April 27, 2000  
IPN-00-033

Subject: **Indian Point 3 Nuclear Power Plant**  
**Docket No. 50-286**  
**Proposed Technical Specification Changes Associated With**  
**Pressure-Temperature and Overpressure Protection System**  
**Limits for Up To 16.2 Effective Full Power Years**

**PROPOSED REVISIONS TO TECHNICAL SPECIFICATION CHANGES ASSOCIATED  
WITH PRESSURE-TEMPERATURE AND OVERPRESSURE PROTECTION SYSTEM  
LIMITS FOR UP TO 16.2 EFFECTIVE FULL POWER YEARS**

FIGURE 3.1-1

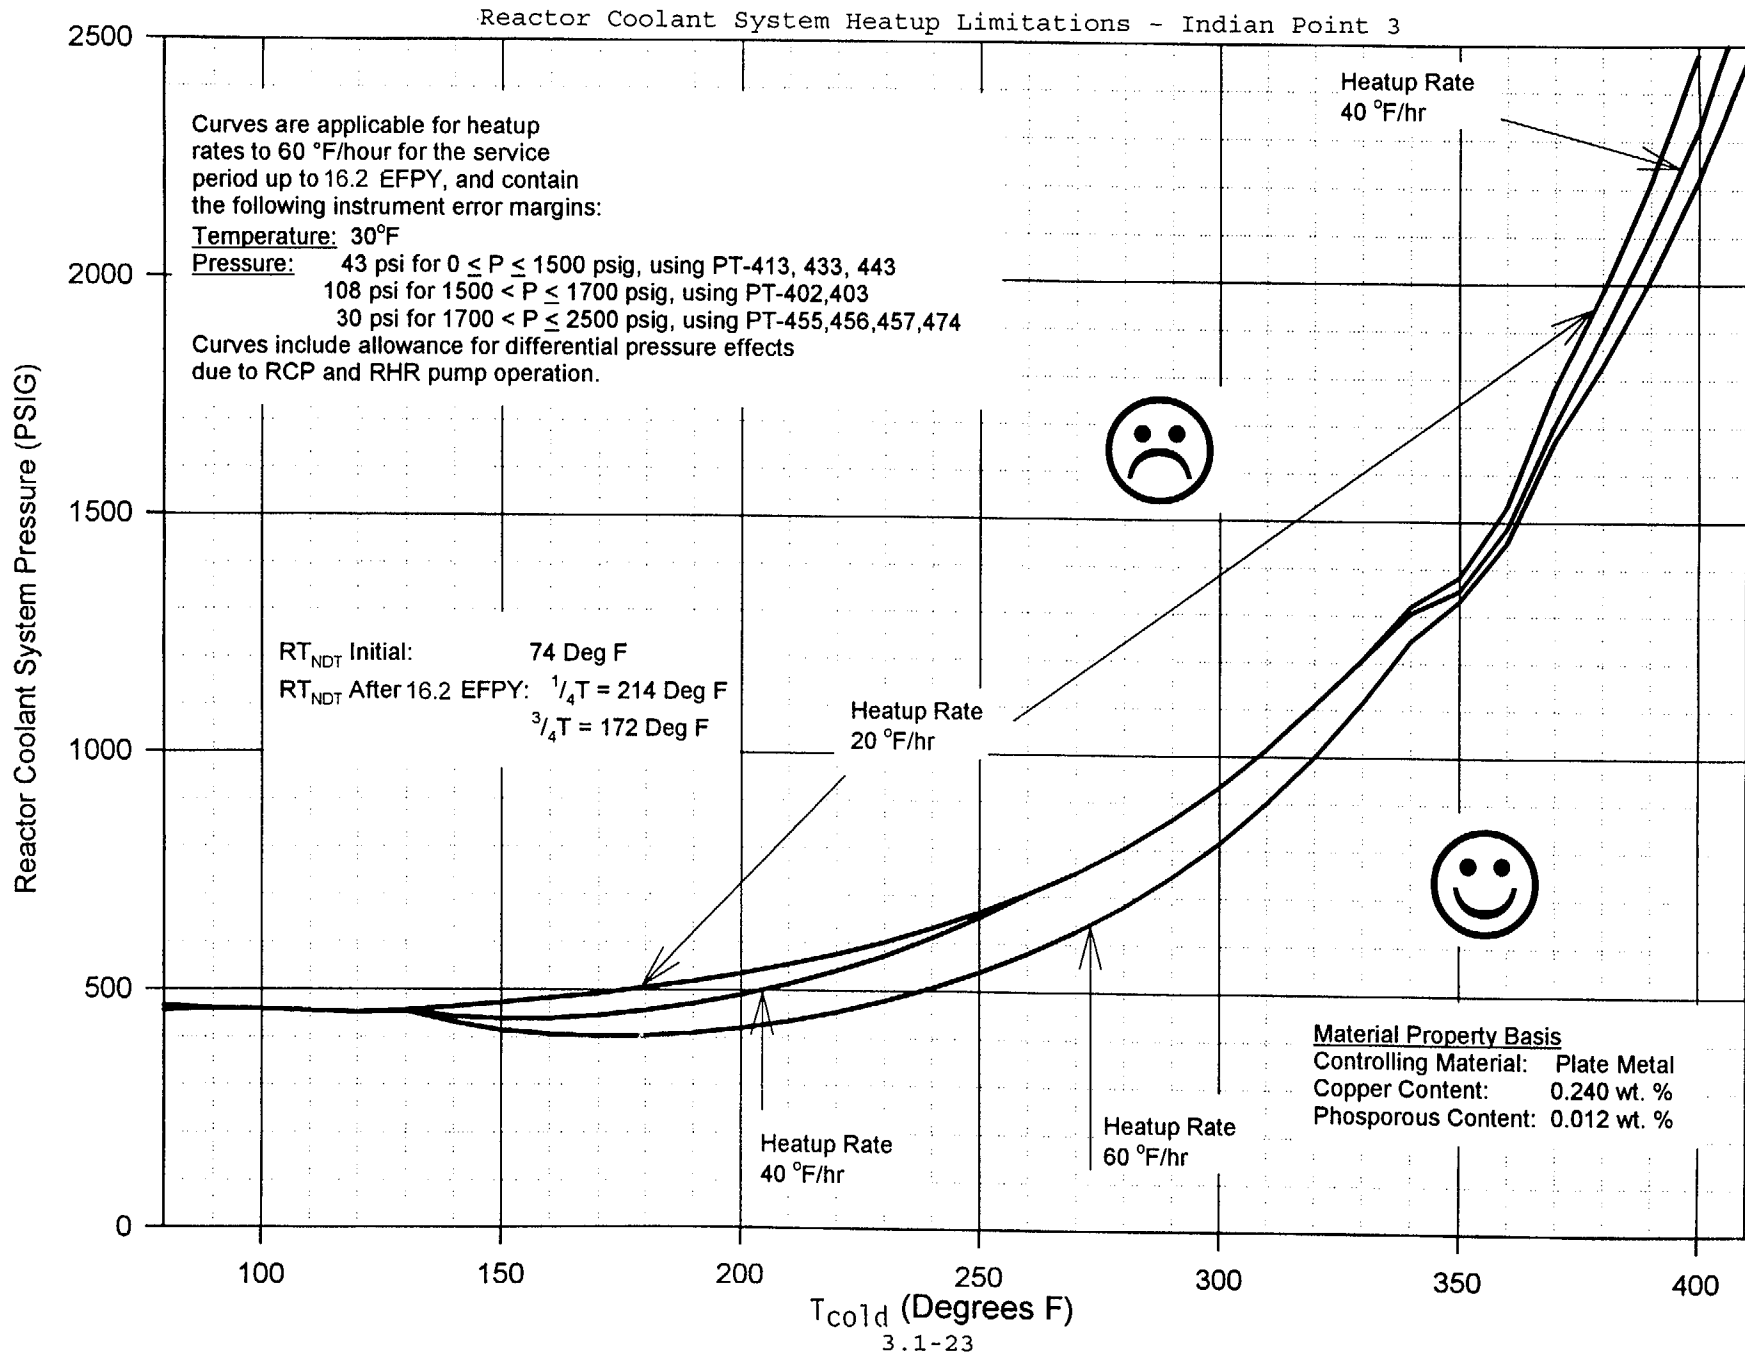
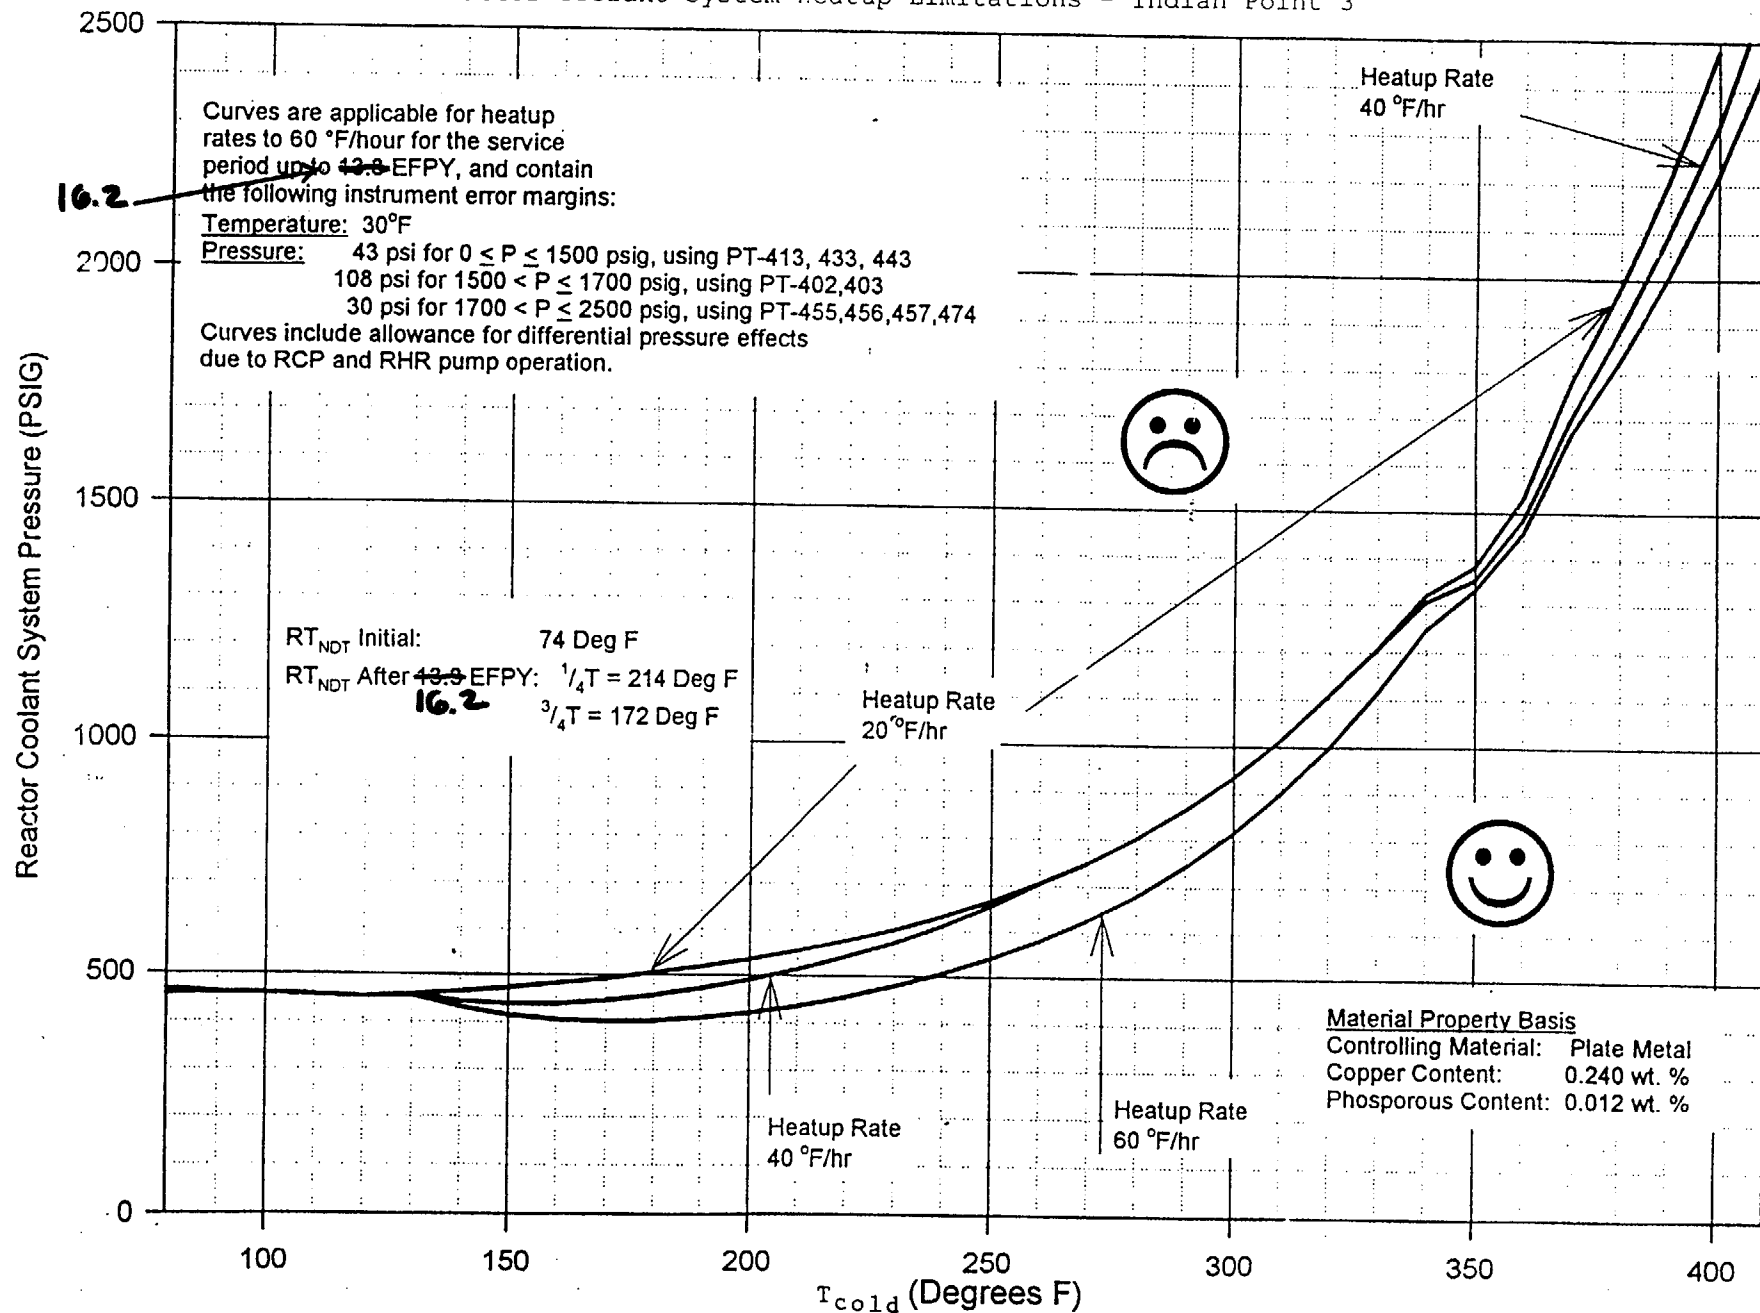
8. **Figure 3.1-1**

Replace:

FIGURE 3.1-2

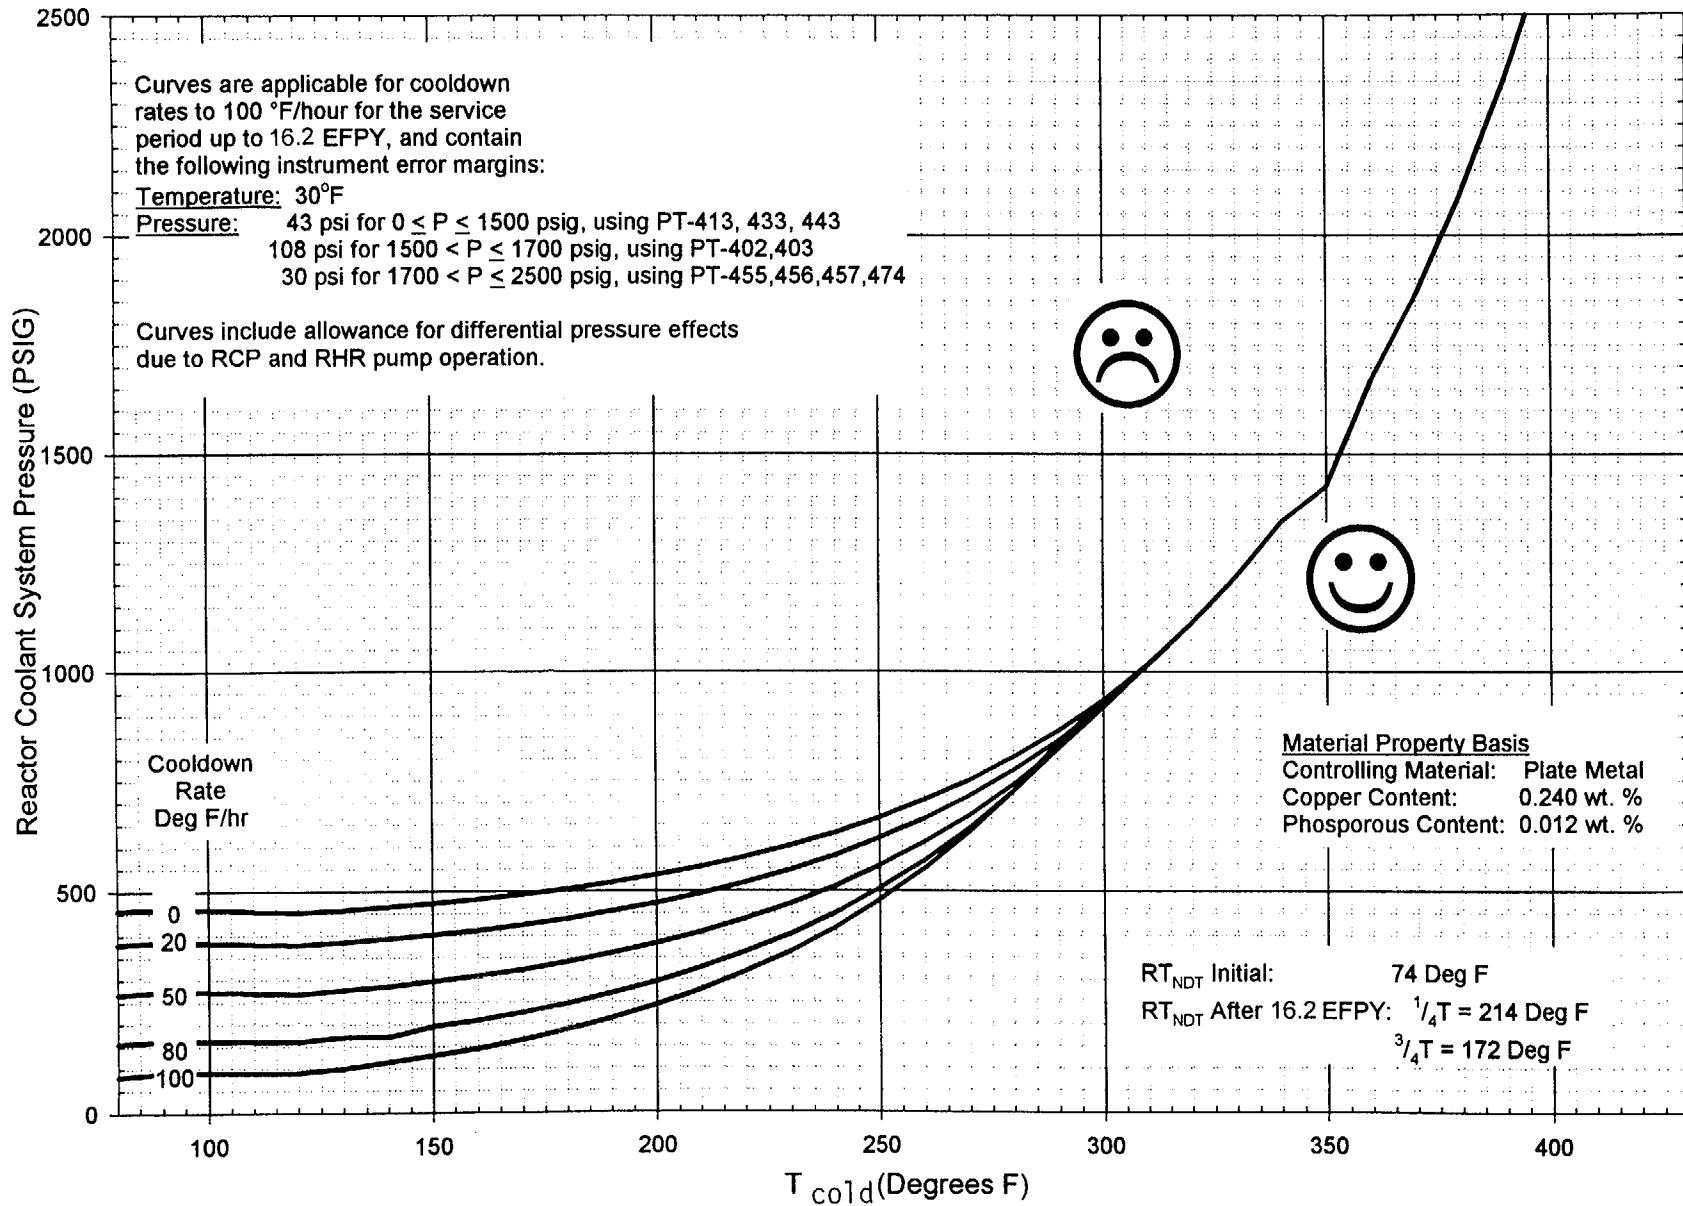
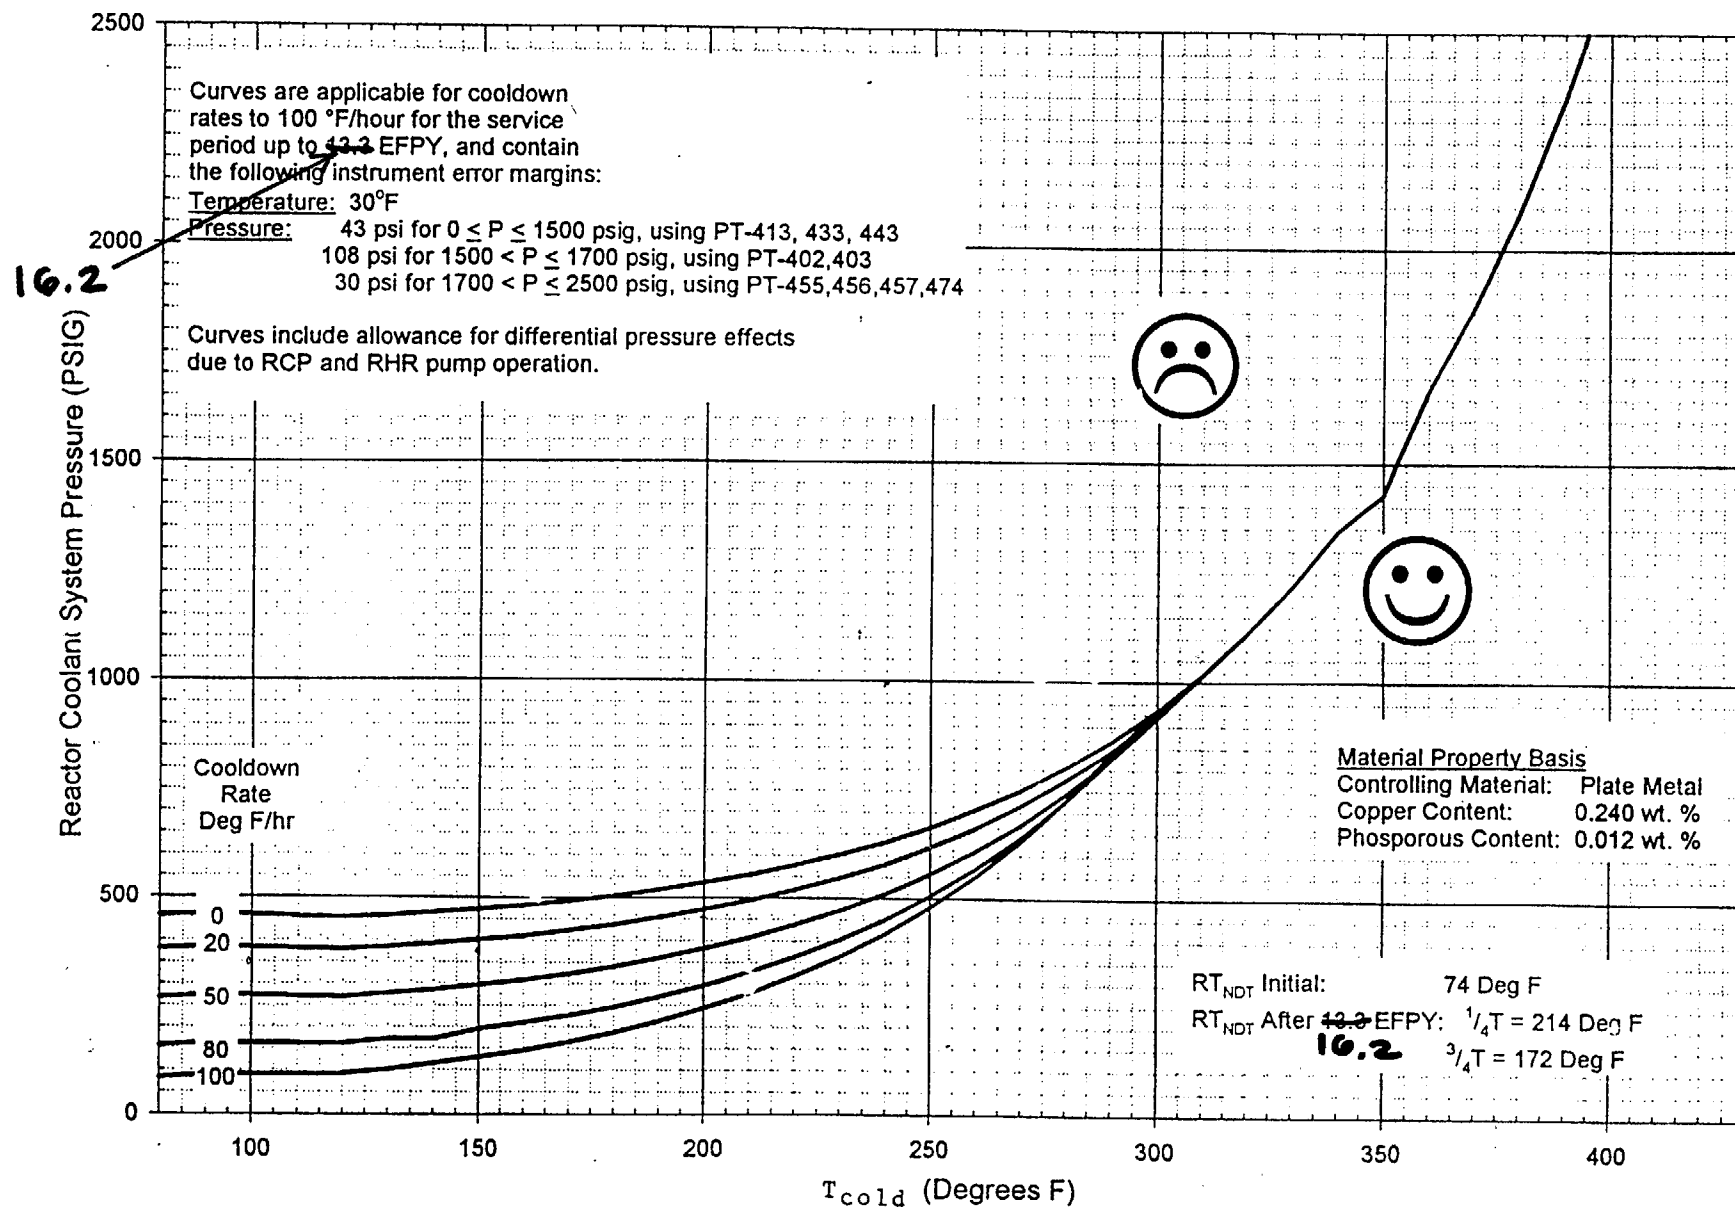
9. **Figure 3.1-2**

Replace:
